SEWAGE DISPOSAL SYSTEM

MARYLAND STATE DEPARTMENT OF HEALTH*

HOWARD COUNTY

P 31311
A REPAIR

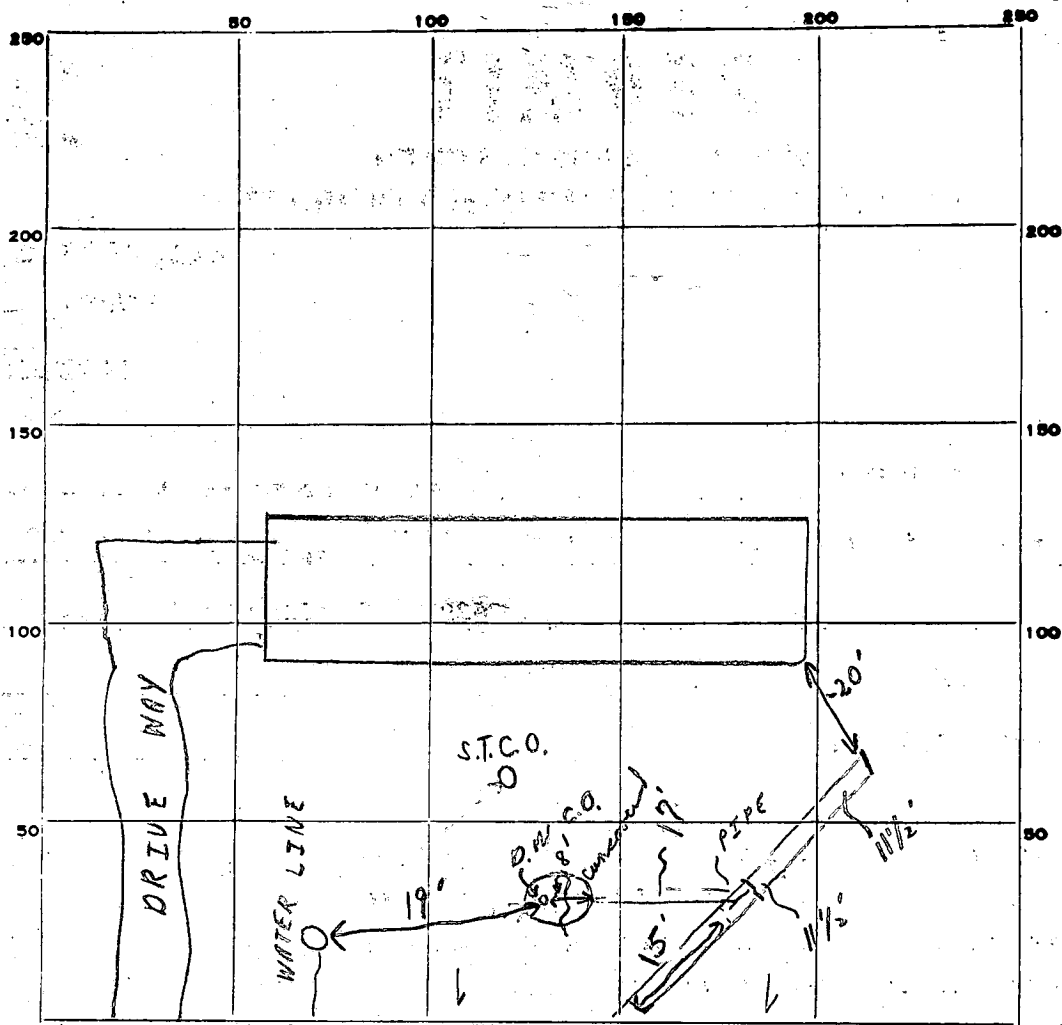
REPAIR - CALL FOR INSPECTION WHEN GROUND IS OPENED UP SO SANITARIAN CAN RECOMMEND

REPAIR. 4/20/81 ⊗ CHECKED - RECOMMEND - TRENCH IN AREA OF DRAWING ON BACK - DUE TO WATER LINE ON LEFT OF EXISTING DRY WELL AND TOPO OF LOT.

REMARKS 4/20/81(N) CHECKED - PART OF TRENCH - 24' STONE IN, REMAINDER
OR FOR STONE. (2) SYSTEM INCOMPLETE. TRENCH TO 2 1/2' OF
SURFACE AVERAGE, NEED PAPER ON TRENCH, (3) SYSTEM COMPLETE.
 C.B.S. C.B.S. C.B.S.
